E5061B-05

S E R V I C E N O T E

E5061B Network Analyzer, 5 Hz to 3GHz

Compatibility issue between Touch Screen Controller and HDD

5012-8672 (DR-12) Picture

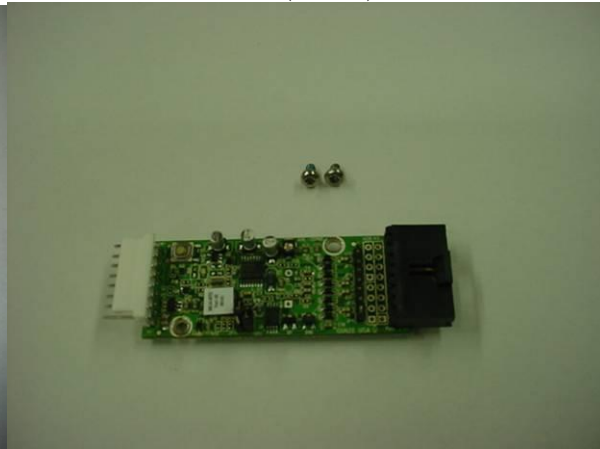
5012-8672, DR-12 Touch Screen Controller board needs DR-12 driver on the HDD. The DR-12 driver is in the E5061-82201 HDD only.

0960-2972, SR-10 Touch Panel Controller needs SR-10 driver on the HDD. The SR-10 driver is in the E5061-82202 HDD only.

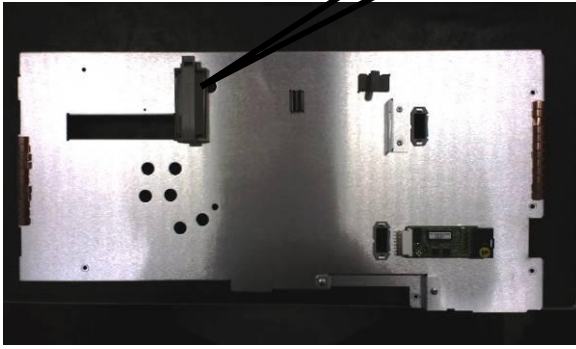
Step-1: Replace E5061-61617 with E5061-61627.

Connect the both end connectors of the wire assembly part properly.

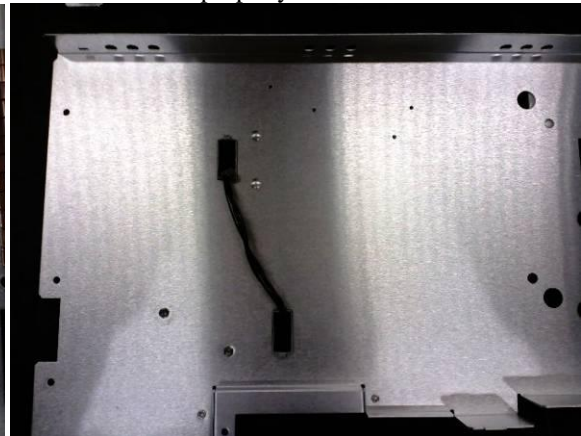
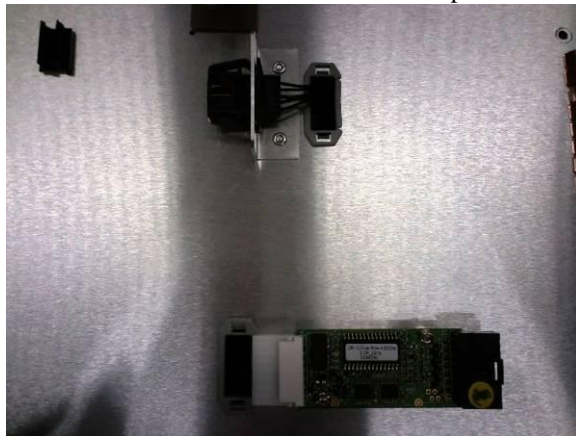
Step-3: Replace E5061-00601 with E5061-00611.

Paste the cable clamp parts (1400-3156, 1400-1391 and 1400-3337) to the individual proper location on the back cover as the picture.

Step-4: Pass the white connector of the cable through the new hole then return it through the current hole from behind.

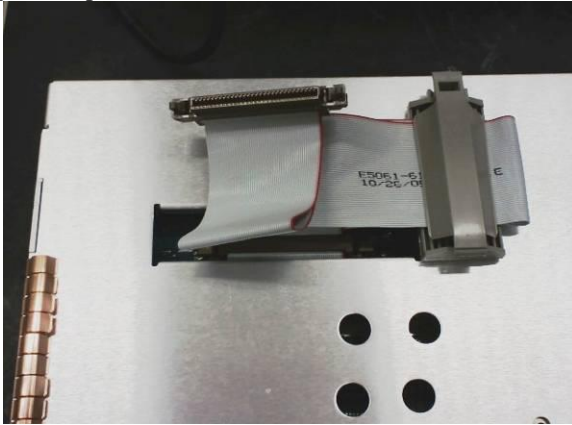
Step-5: Insert another connector to the bracket next to the new hole.
Connect the white connector to the touch panel module controller board properly.

Step-6: Put the back cover on the front assembly module then fix with 6pcs of screw 0515-0430.
Then, connect the cable from the touch panel module to the controller board.

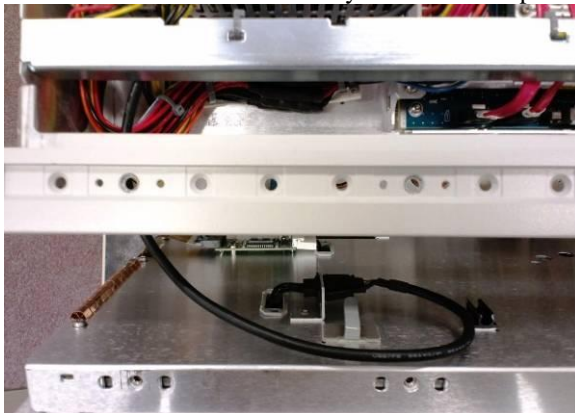
Step-7: Connect the cable E5061-61631(which is re-used item from the original instrument) and make a shape correctly as the picture.

Step-8: Connect the cable to J18 port on the CPU board, then paste a cable clamp on the sidewall of the PSU as the picture.

Then, clamp the cable properly and run through under the bar properly then tie the cable with other cables together with a cable tie 1400-0249.

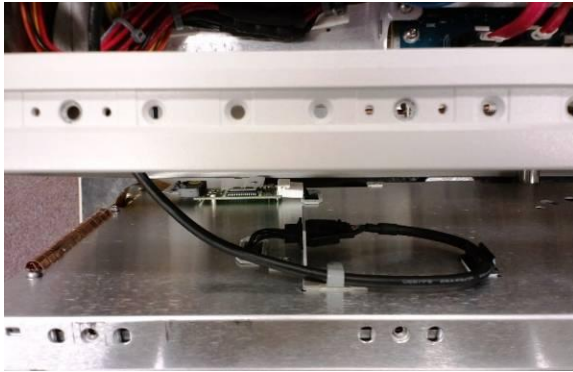
Step-9: Put the front assembly module in front of the chassis as the picture, then connect another USB connector of the cable to the front assembly module as the picture.

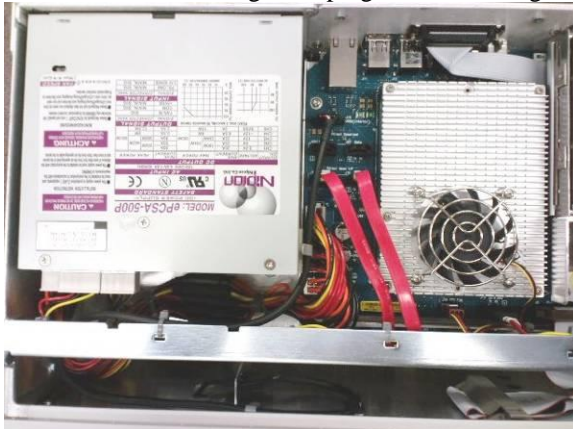
Step-11: Install the front assembly module to the chassis completely, then check cable caught between the front assembly module and the chassis visually.

Next, fix the installed front assembly module with 7pcs of screw, 0515-1382.
